City of Ramsey
Agenda
Environmental Policy Board (EPB)

Consider Natural Resources Aspects of Site Plan and Final Plat for Skyline Apartments (Project No. 24-110);
Case of PSD, LLC

PROPOSED MIXED USE BLDG.
SKYLINE ON SUNWOOD
RAMSEY, MN

Project No. 220705
Issue Date: May 13th, 2024
Document Set: SITE PLAN SUBMITTAL

LANDSCAPE PLAN

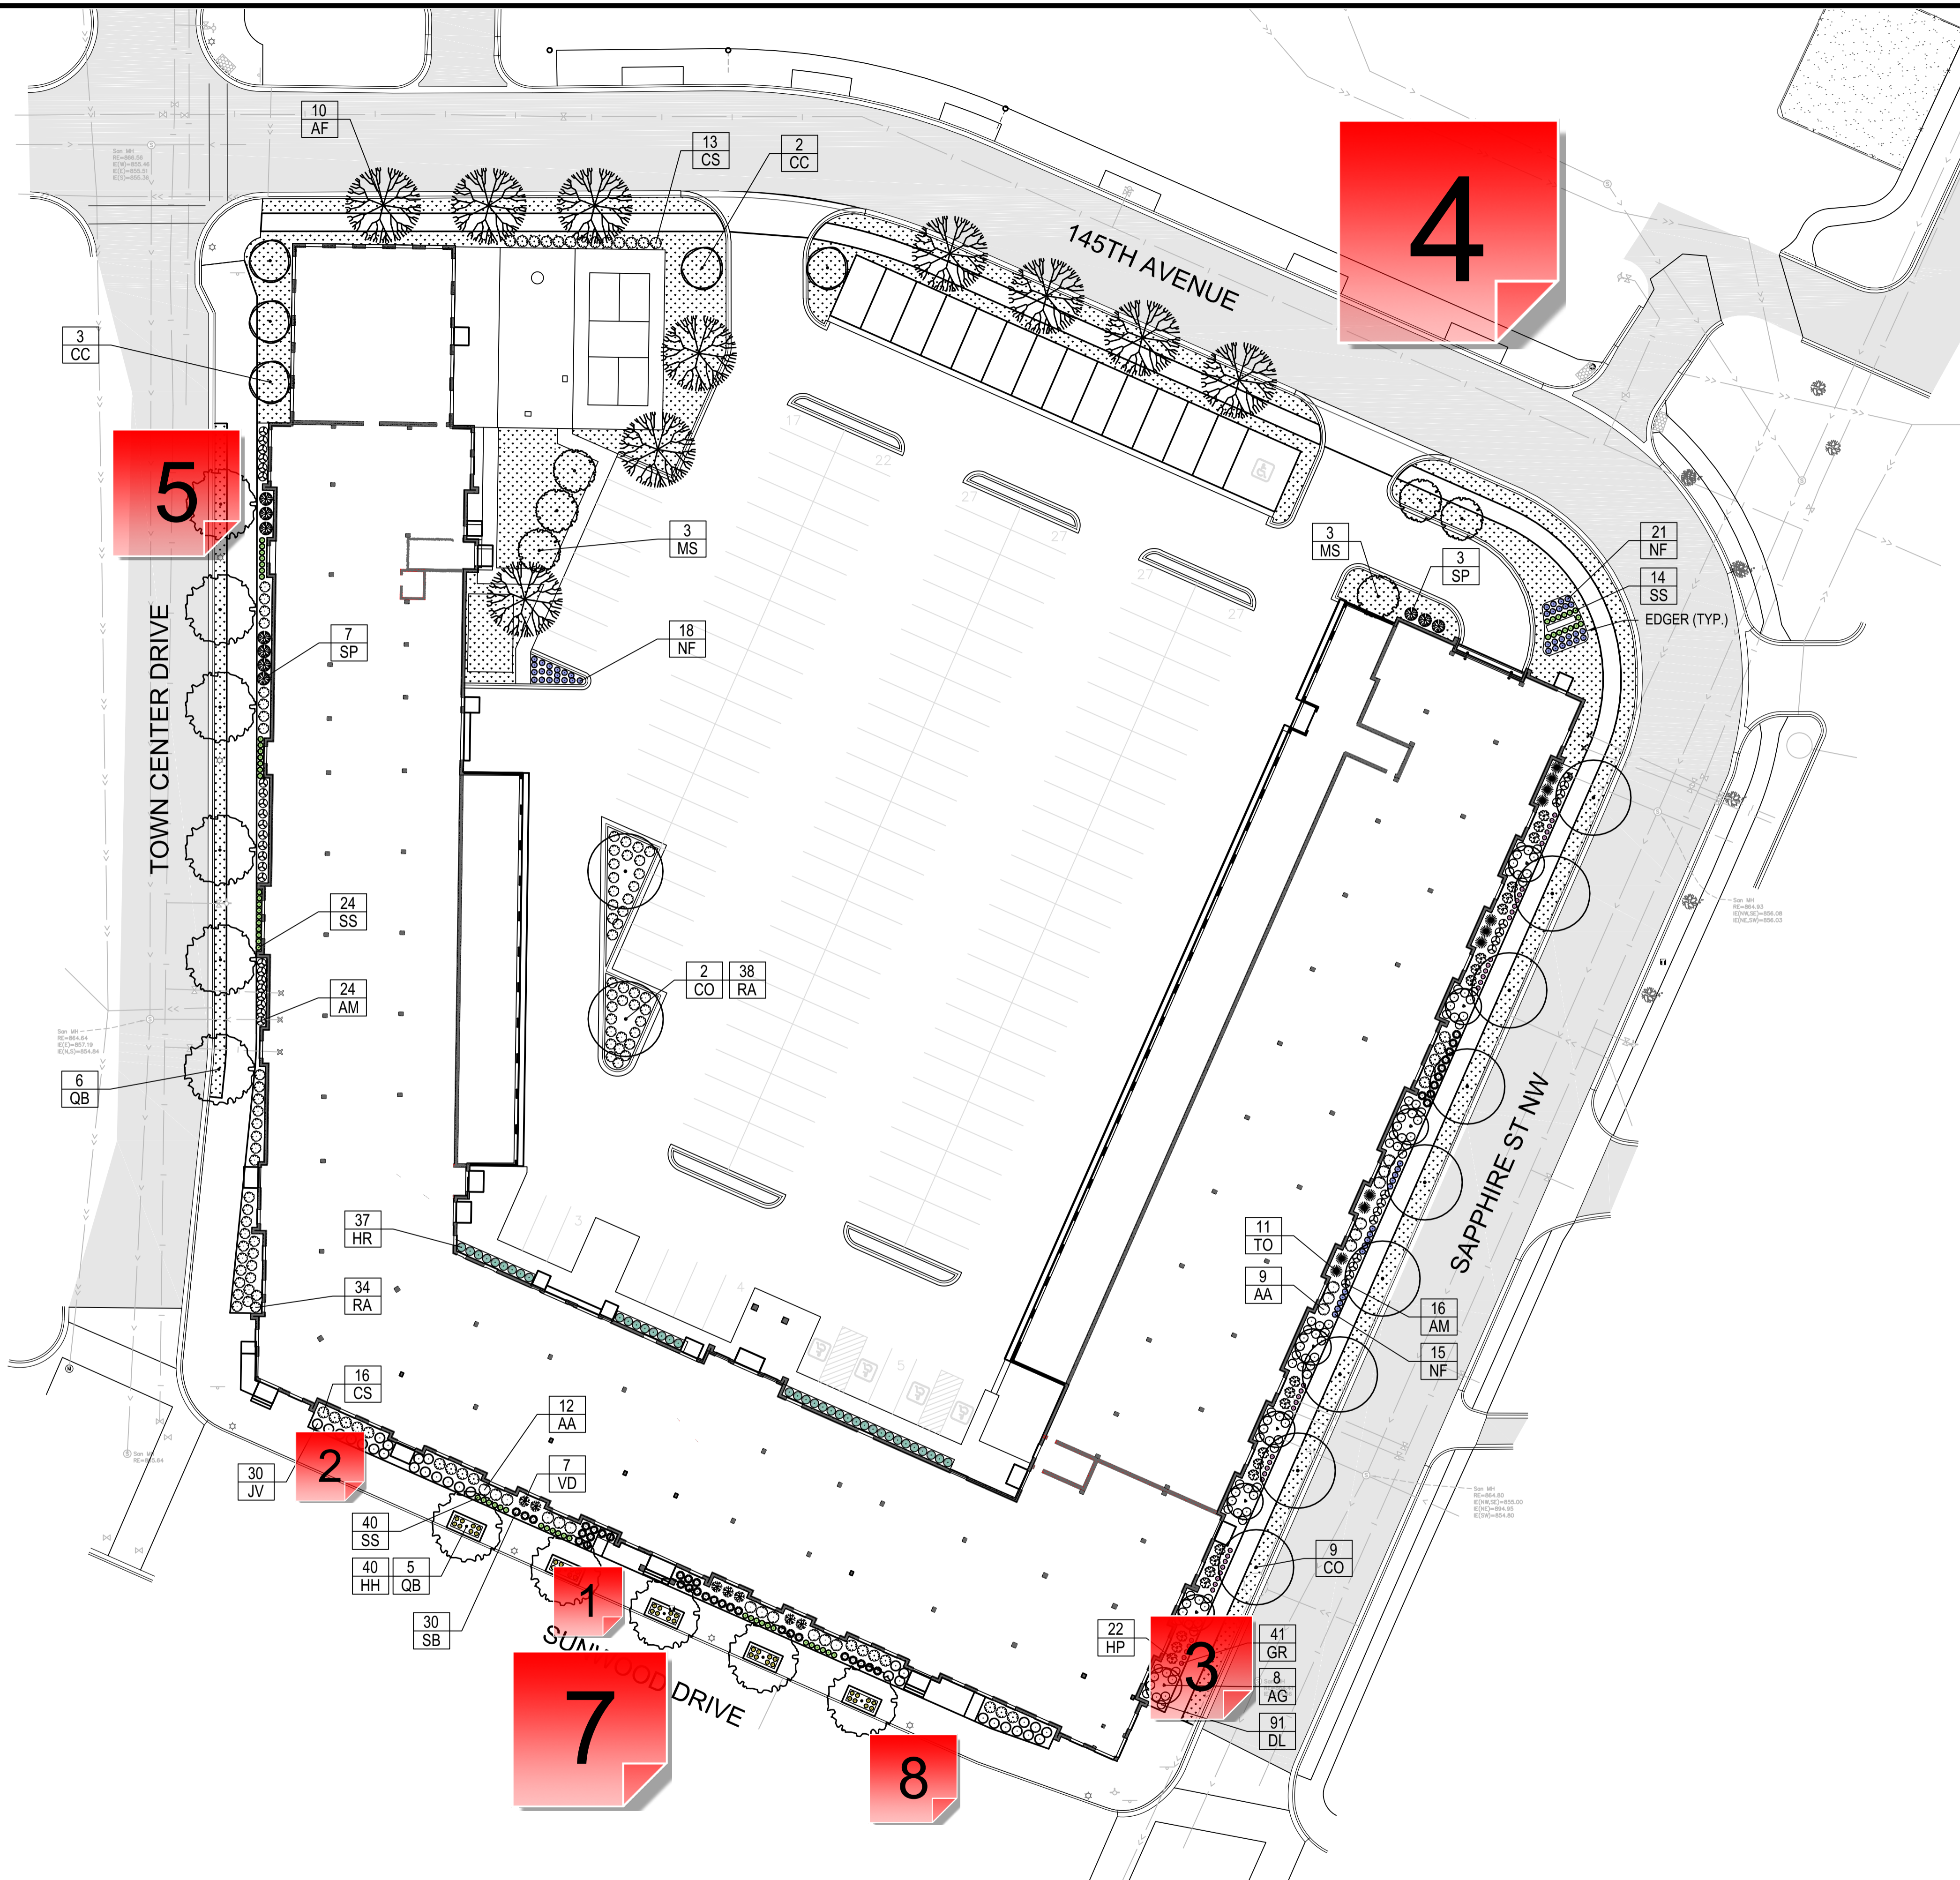
Please modify the sidewalk adjacent to the retail space so that it is ten (10) feet wide. This would include eliminating the boulevard and plantings adjacent to the retail space.

Please add the size for the Thornless Hawthorn

Please extend irrigation to cover the planting beds and boulevards. The specification for irrigation for the Sunwood Drive planting beds has been uploaded into the Documents folder in ProjectDox.

Mink mulch must be used in the planter beds along Sunwood Drive (in the public road right-of-way).

PLANTING DETAILS & LANDSCAPE SPECS.

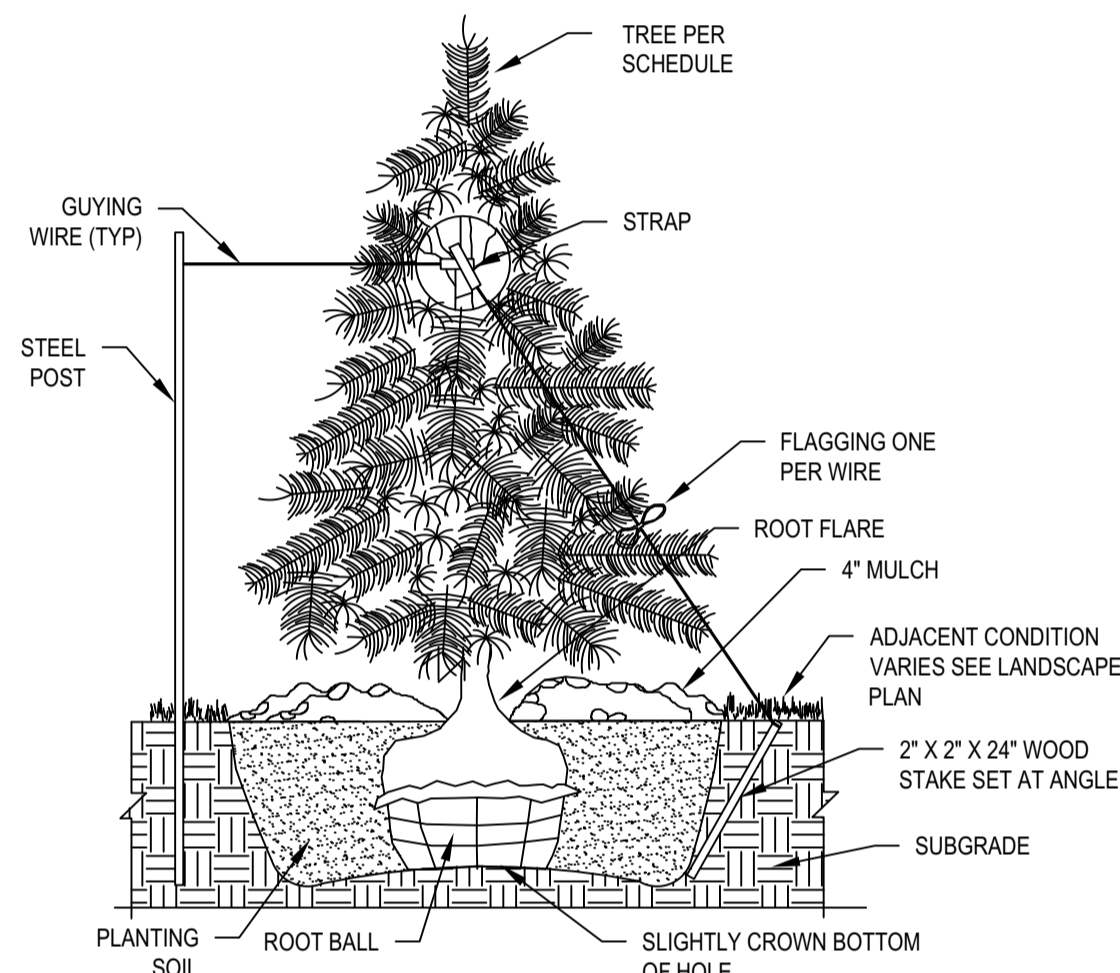
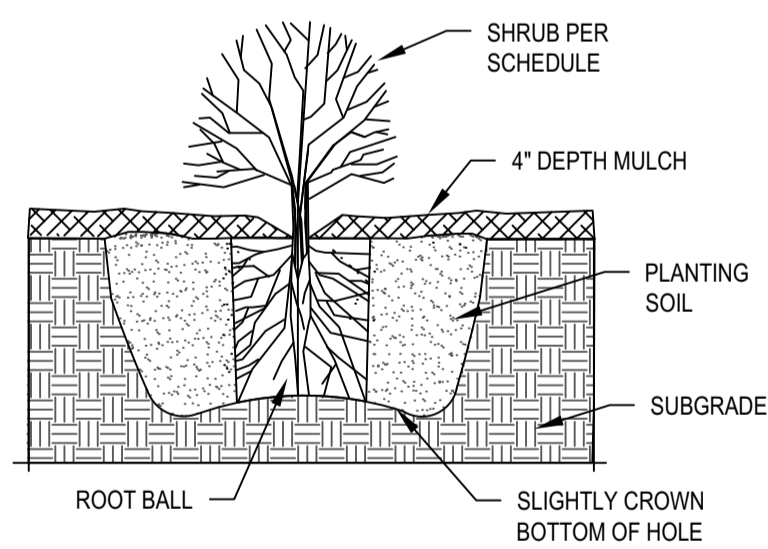
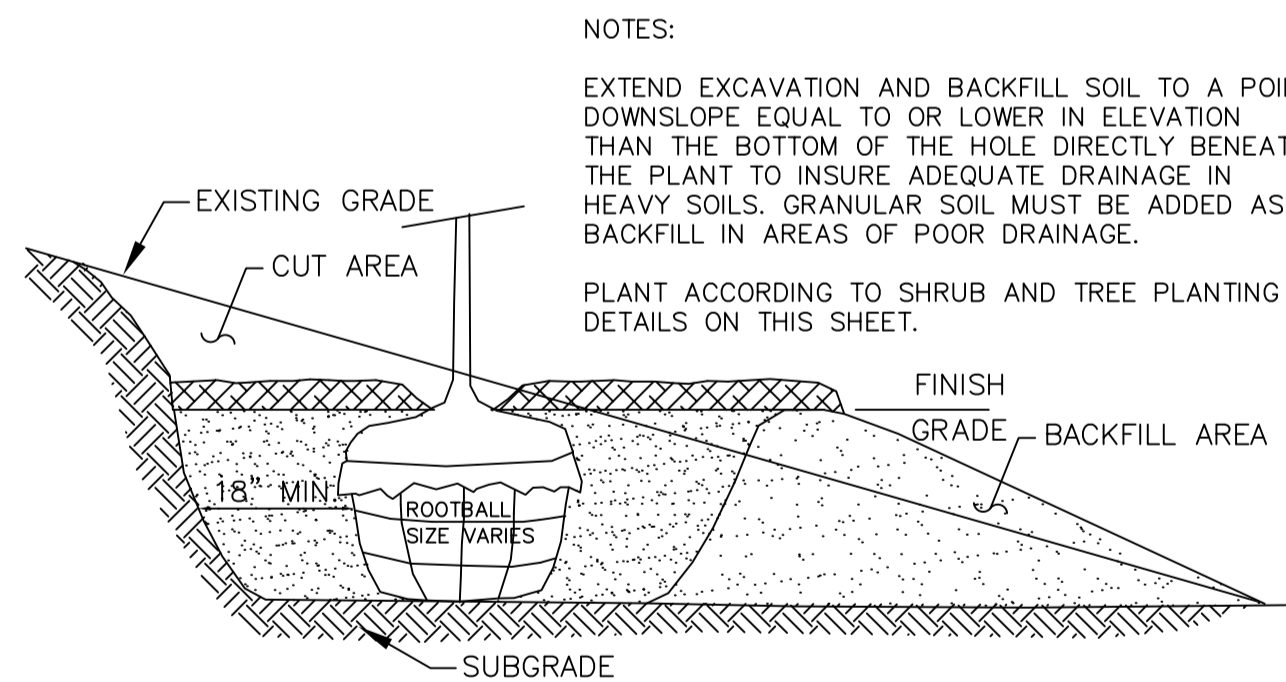
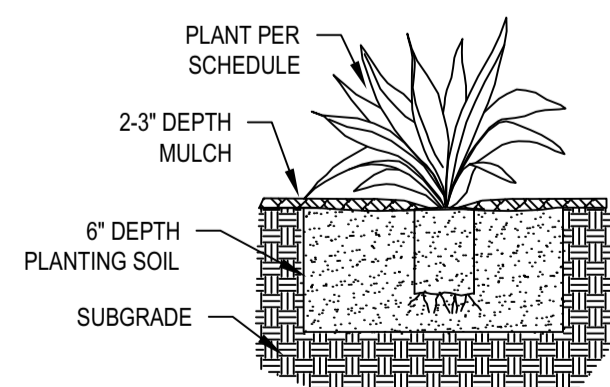
The City's Development Agreement will require a 2-year maintenance guaranty. Recommend modifying 7.A. to specify a 2-year warranty.

1 SUNWOOD DRIVE PLANTING BED
NOT TO SCALE

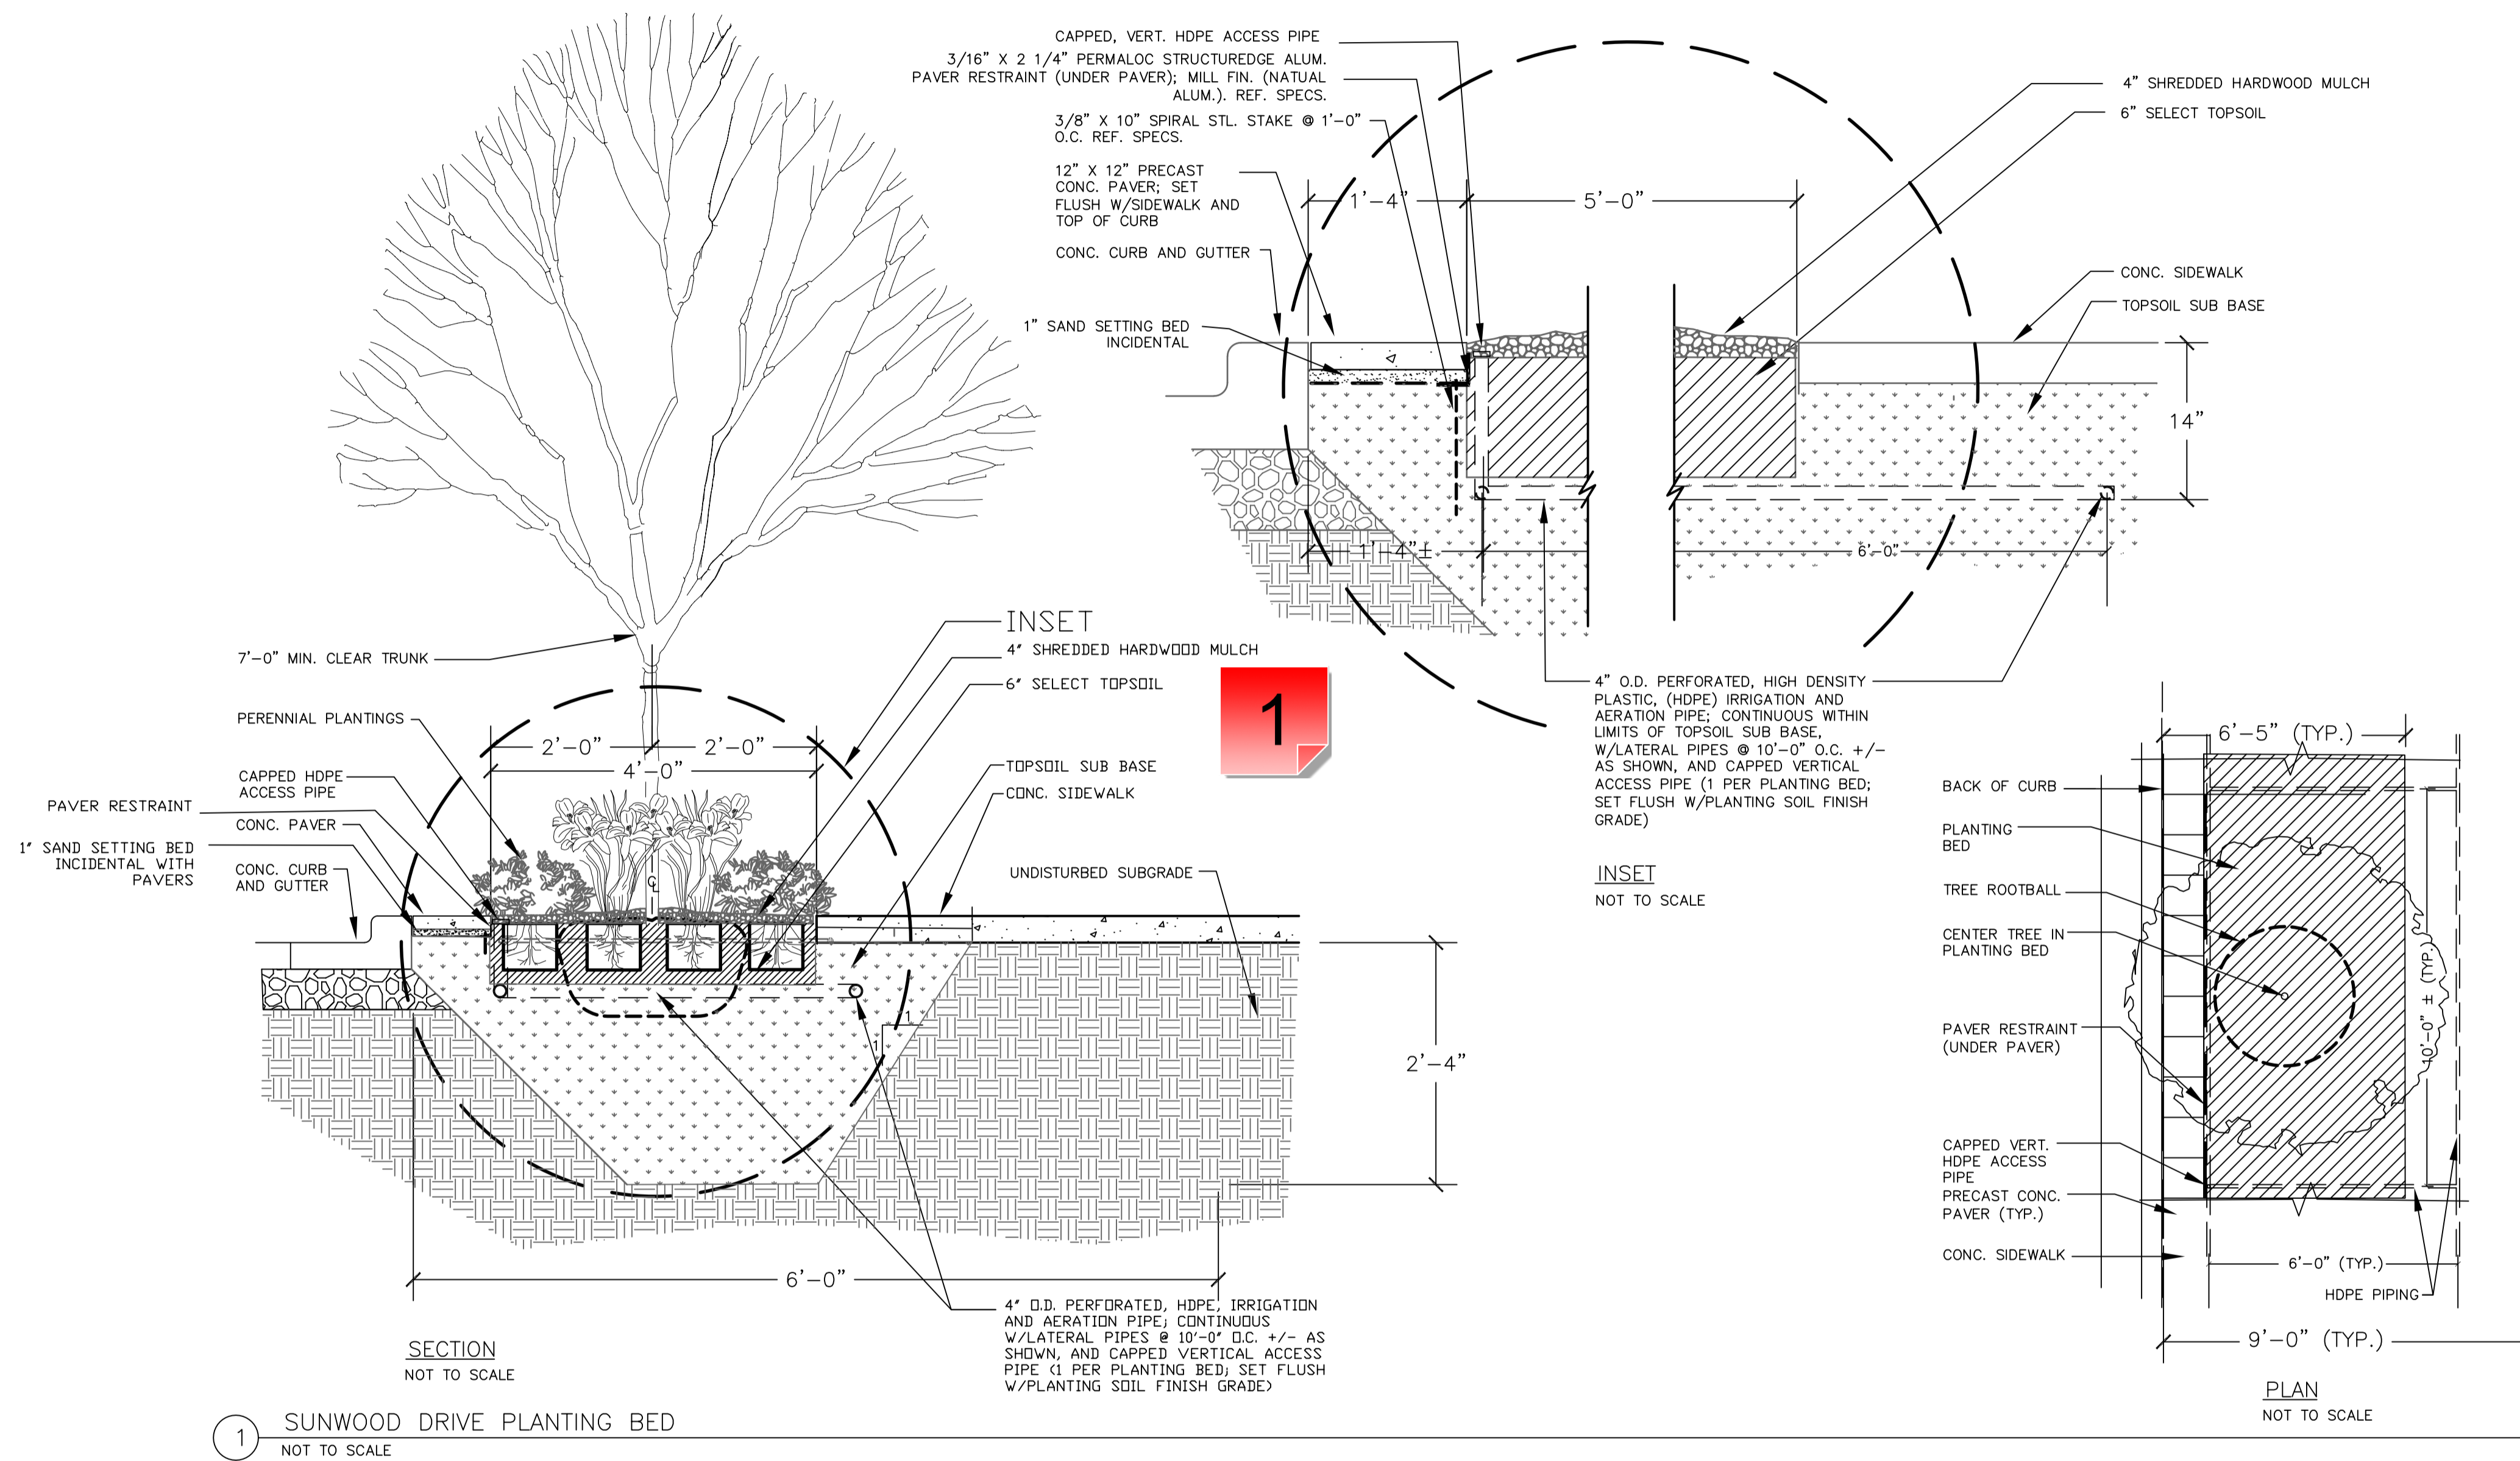
Please extend the irrigation system to cover the plantings in the right-of-way along Sunwood Drive, Sapphire Street, and 145th Avenue.

Please specify that mink mulch is to be used in the Sunwood Drive planter beds (in the public road right-of-way).
